35/13-00G 5912 Cedar Parkway (Chevy Chase Village HD)

#### HISTORIC PRESERVATION COMMISSION STAFF REPORT

Address: 5912 Cedar Parkway Meeting Date: 04/12/00

**PROPOSAL:** Alterations and new addition **RECOMMEND:** Approval

## PRO DOSED PARTIAL FRONT ELEVATION

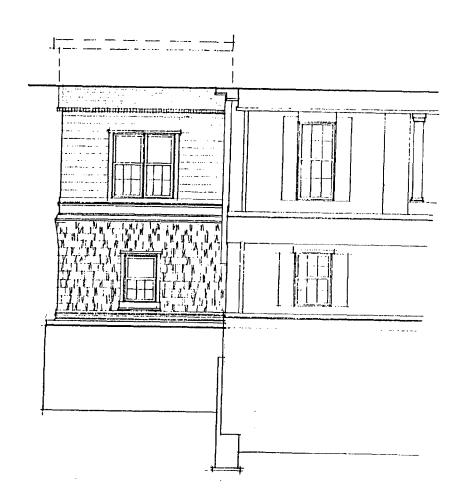
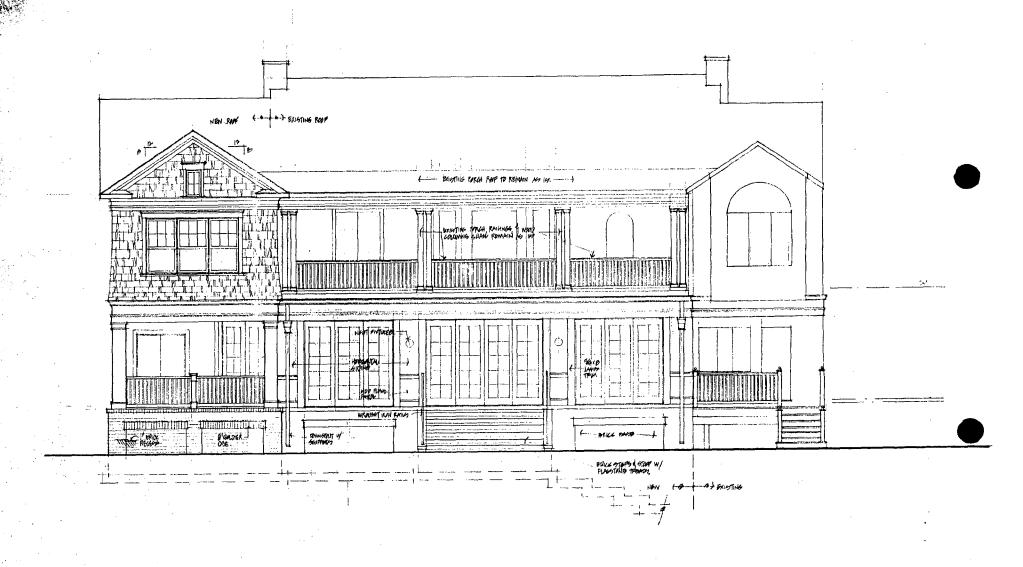
The proposed addition is modest, and appears to be compatible in terms of massing, scale and materials. While the side addition is using the original house for the basic design, there will be sufficient differences, including the groupings of windows and the fenestration pattern, which will serve to differentiate the construction. With the new addition held back from the front elevation even more than the existing side elevation, staff feels that it helps to reduce the impact of the new addition on the existing front elevation.

> The LAP concurs with the approval of the proposed work. The addition at > the side is set back from the front façade even more than the existing > addition on the other side of the front elevation. Staff conditions for > painted trim and tree-save measures are entirely reasonable. Several > members of the LAP expressed concern for the trees to be removed or > endangered by the new driveway construction. We believe this issue is > already sufficiently covered by the Village permit review process, but the > applicant should be reminded that approval from the Village will be > required: The Village Building Code states, Section 8-17: " Unless a > special permit has been obtained from the Board of Managers, no permit > shall be issued for the construction of any improvement which may > reasonably be expected to injure a tree of any size on an abutting or > nearby property, unless the owner of such property grants written > permission; or the removal of which is regulated by Chapter 17."

- 1) The applicant shall undertake all the tree-save measures outlined in the arborist's report, as submitted (see Circle & -9).
- 2) All the wood trim and railings will be painted.
- 3) All the new windows will be wood, with true divided light windows or approved equal.

# ECHEMATIC for KANDEL CONSTRUCTION

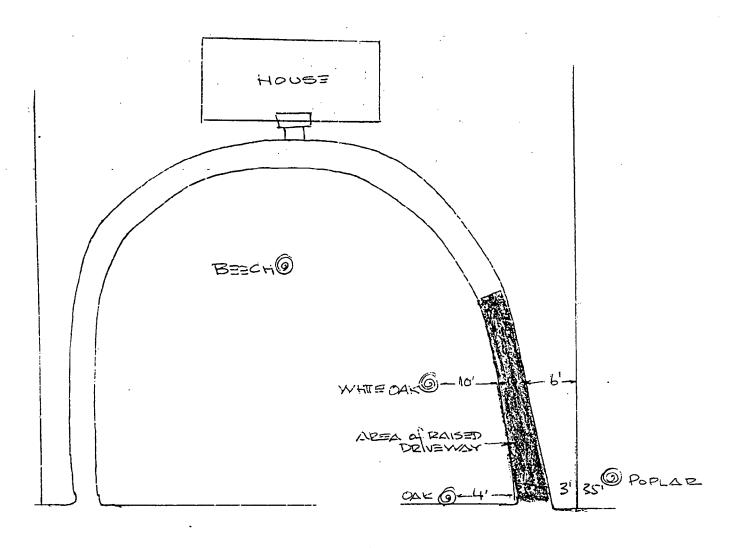
In my professional opinion, the 30" diameter Beech Tree in the center of the area will not be impacted by the construction. The 27" diameter White Oak tree will have some minor damage to its critical root zone. The 34" diameter Tulip Poplar on the next door neighbors' property and the 8" diameter street tree will have more root damage.

- The driveway area that is shown as shaded on the sketch is the most important in root damage. This area should be excavated no more than 4 inches deep for the gravel base. The asphalt layer may be placed on top of this.
- ♦ The driveway pavement can be held in place with steel edging or additional gravel built against the sides of the paving. This can then be landscaped with ground cover plants.
- The subject trees should be deep root fertilized/aerated according to the following. Drill or auger 2-inch diameter holes, 24 inches apart, approximately 10 to 15 inches deep in concentric rings in the area of the drip line of the trees. In the case of the Poplar Tree, much of this operation will be on the neighbors' property. These holes

are then filled to within 4-inches of the top with a mixture of half 10-10-10 granular fertilizer (or approved equal) and half humus (or approved equal). This work should be done within the next four weeks, and be done by a certified arborist.

• If there are drought conditions this summer, these trees should be irrigated on a regulated basis. The holes that were drilled will act as channels for the water to enter the critical root zone.

# ECHEMATIC for KANDEL CONSTRUCTION

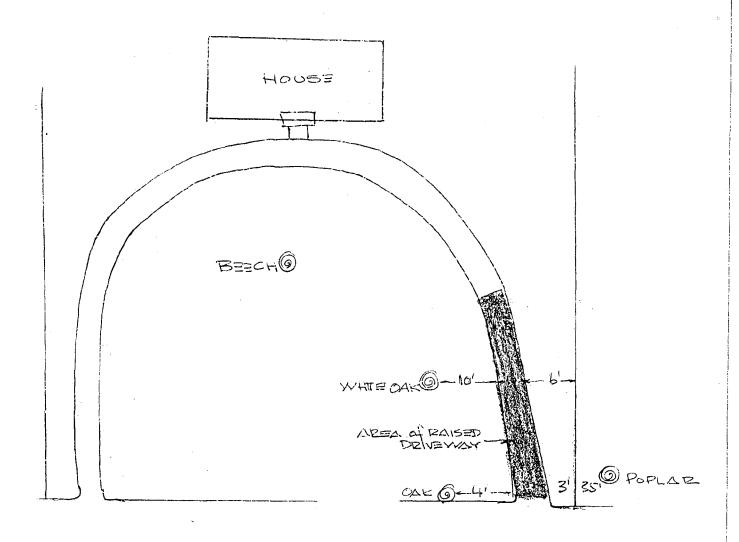
In my professional opinion, the 30" diameter Beech Tree in the center of the area will not be impacted by the construction. The 27" diameter White Oak tree will have some minor damage to its critical root zone. The 34" diameter Tulip Poplar on the next door neighbors' property and the 8" diameter street tree will have more root damage.

- ♦ The driveway area that is shown as shaded on the sketch is the most important in root damage. This area should be excavated no more than 4 inches deep for the gravel base. The asphalt layer may be placed on top of this.
- ♦ The driveway pavement can be held in place with steel edging or additional gravel built against the sides of the paving. This can then be landscaped with ground cover plants.
- ♦ The subject trees should be deep root fertilized/aerated according to the following. Drill or auger 2-inch diameter holes, 24 inches apart, approximately 10 to 15 inches deep in concentric rings in the area of the drip line of the trees. In the case of the Poplar Tree, much of this operation will be on the neighbors' property. These holes

are then filled to within 4-inches of the top with a mixture of half 10-10-10 granular fertilizer (or approved equal) and half humus (or approved equal). This work should be done within the next four weeks, and be done by a certified arborist.

♦ If there are drought conditions this summer, these trees should be irrigated on a regulated basis. The holes that were drilled will act as channels for the water to enter the critical root zone.
